PLANNED UNIT DEVELOPMENT APPLICATION (PUD 2005-000002)

Project Name: Ho'omau I Mua
Applicant & Consultant: Riehm Owensby Planners Architects
Petitioner: Donald S. Rullo
Tax Map Key: 8-7-013: 006

Exhibit A: Master Plan

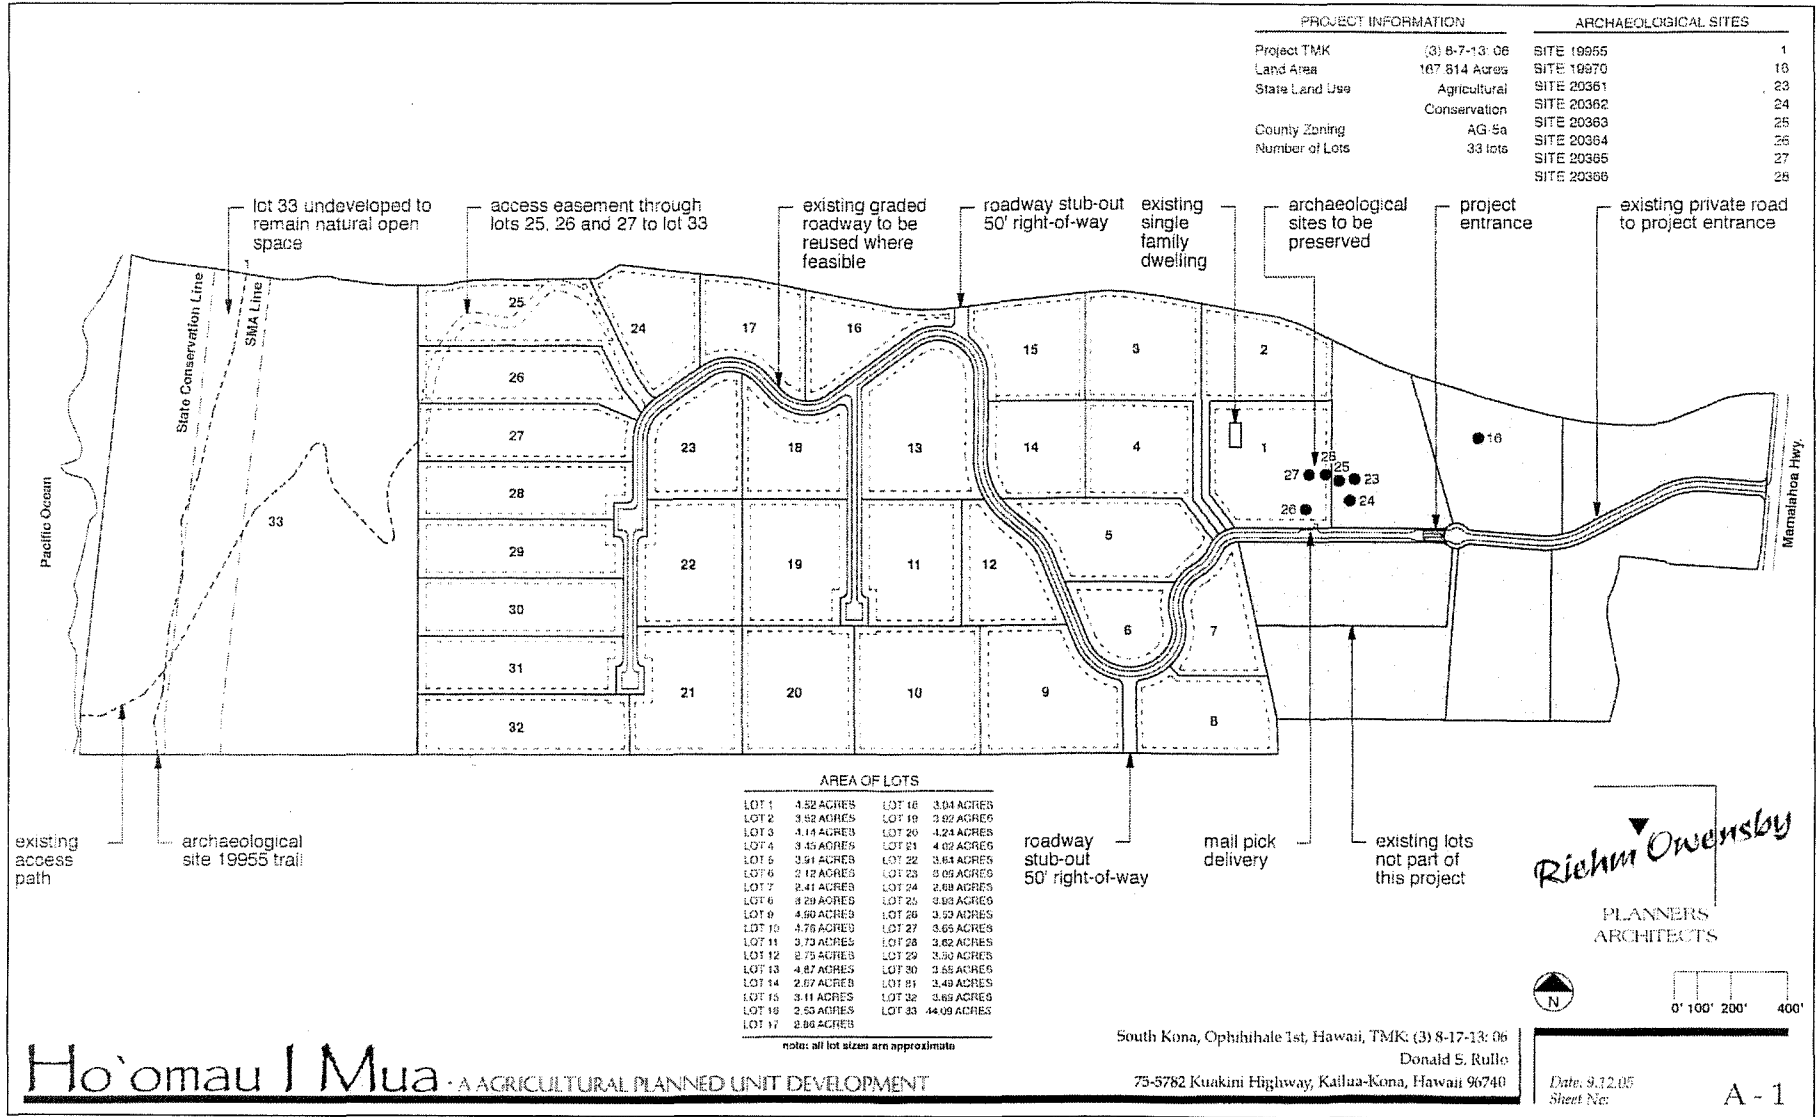
PUD enables the preservation of coastal open space by creating a large shoreline lot that extends greater than 1000' inland to the topographic knickpoint where the land starts to rise. To compensate for the large coastal open space, the site plan shows 32 developable lots smaller than the 5-acre minimum lot size. The site plan also includes public shoreline access easements and archaeological sites buffer easements (see Exhibit A).

- b. General Plan. The proposed farm dwellings and agricultural use are consistent with the General Plan LUPAG designation of Extensive Agricultural. The General Plan promotes public access to shoreline areas and protection of historic sites (General Plan, February 2005, section 8.3). Therefore, the conditions to this PUD require the provision of a mauka-makai and lateral public access through the subject property, and the depiction of archaeological buffer easements on the final plat map, as proposed in the PUD application and shown in Exhibit A.

- C. Subdivision Approval. Subdivision approval shall be subject to the following conditions:
 1. Conformance with Master Plan. The final plat map shall show the lot layout, public access easement, and archeological sites buffer easements as substantially represented in the master plan attached as Exhibit A. The representation that the large shoreline lot will remain undeveloped and restricted from further subdivision shall be supported by appropriate notation on the plat maps and legal documentation.
